Item 18: 2027 ERCOT Methodologies for Determining Minimum Ancillary Service Requirements

Board of Directors Meeting

Date: September 7, 2026
To: Board of Directors
From: Nitika Mago, Director Balancing Operations Planning
Subject: 2027 ERCOT Methodologies for Determining Minimum Ancillary Service Requirements

ERCOT Methodologies for Determining Minimum Ancillary Service Requirements

Impacts on Quantities for ECRS and NSRS

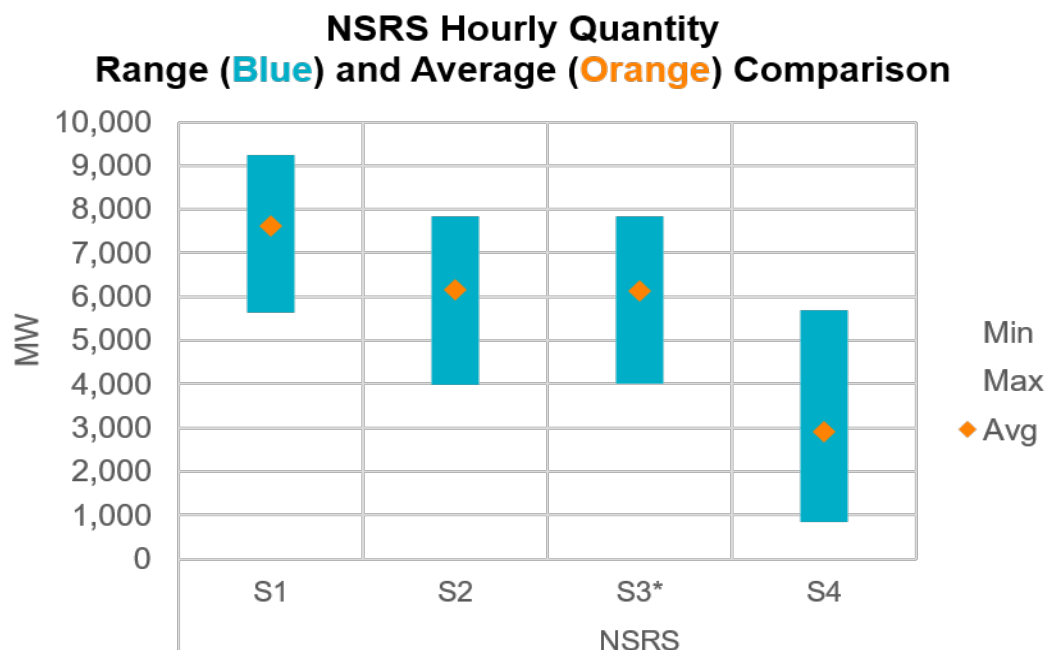
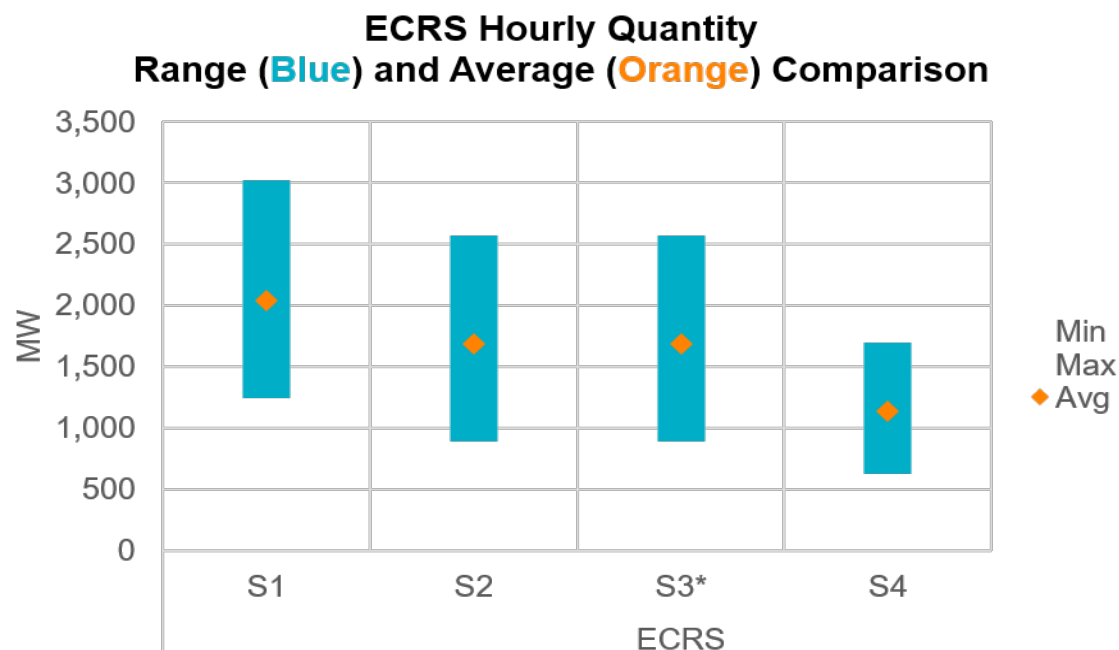
Key Takeaway: ERCOT's recommended ECRS and Non-Spin quantities (S3) reflect a measured outcome — below the maximum that crediting no headroom would result in, but well above the aggressive scenarios that would take on more risk.

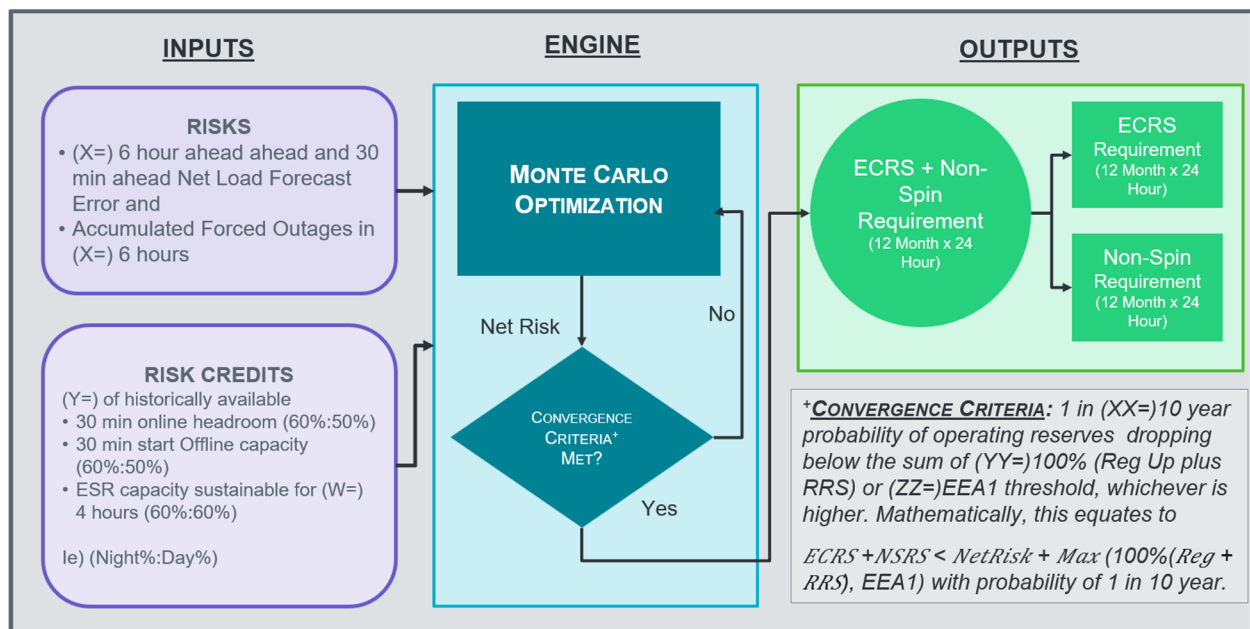
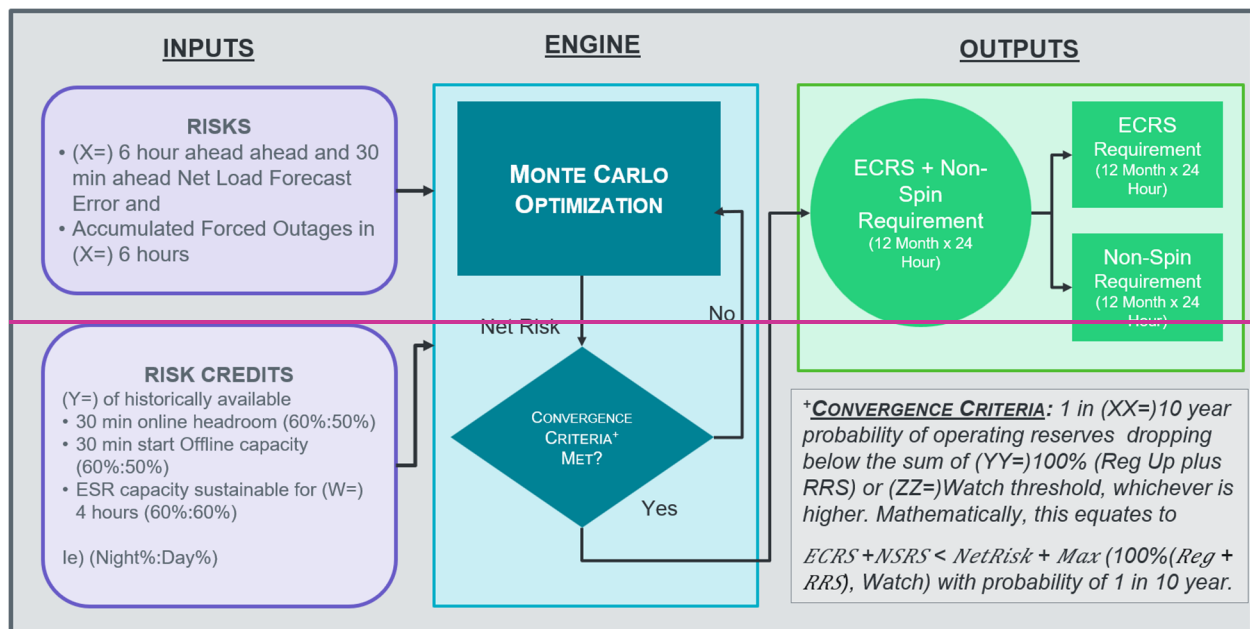
A diagram of a probabilistic methodology used to calculate ECRS and NSRS requirements is shown below. The methodology utilizes an accounting of risk for which ECRS and NSRS are needed and accounting of historic excess Resource capacity that may have ~~available~~ availability to respond to these risks.

Risks ~~accounting includes 30-minute~~ accounted for include 30-minute-ahead and ~~6-six-hour-ahead~~ historic net load forecast errors and historic rolling ~~6-six-hour-ahead forced-outages~~ Forced Outages of ~~conventional~~ dispatchable Resources from the previous four years. ERCOT continues to see significant growth in installed solar capacity from one year to the next; an increase in solar capacity ~~also~~ tends to increase the MW quantity of error in ~~itsthe~~ the forecast. Hence, ERCOT's reliance on historical solar forecast errors alone creates a possibility of under-estimation of the total requirement of ECRS and NSRS. To address this, ERCOT will include an adjustment for expected increase in solar forecast error due to expected increase in installed capacity of solar Resources.

Risk credits are categorized into three groups: (1) historic ~~online~~ On-Line capacity that can be ramped to in 30-minutes, excluding ~~Energy Storage Resources, ESRs,~~ (2) historic ~~offline~~ Off-Line capacity that can be brought ~~online~~ On-Line in 30 minutes, ~~energy storage resource~~ and (3) historic ESR capacity that can be sustained for ~~4~~ four hours.

- for night hours (i.e., Hour Ending (HE) 23 – HE5): 60% of the historically available capacity for night hours (HE23-HE5) for all three risk credit categories. Additionally; and
- for day hours (i.e., HE6 - HE22): 50% of the historically available capacity for online and offline from On-Line and Off-Line Generation Resources and 60% of energy storage resource of the historically available capacity in day hours (HE6-HE22) as inputs, from ESRs.
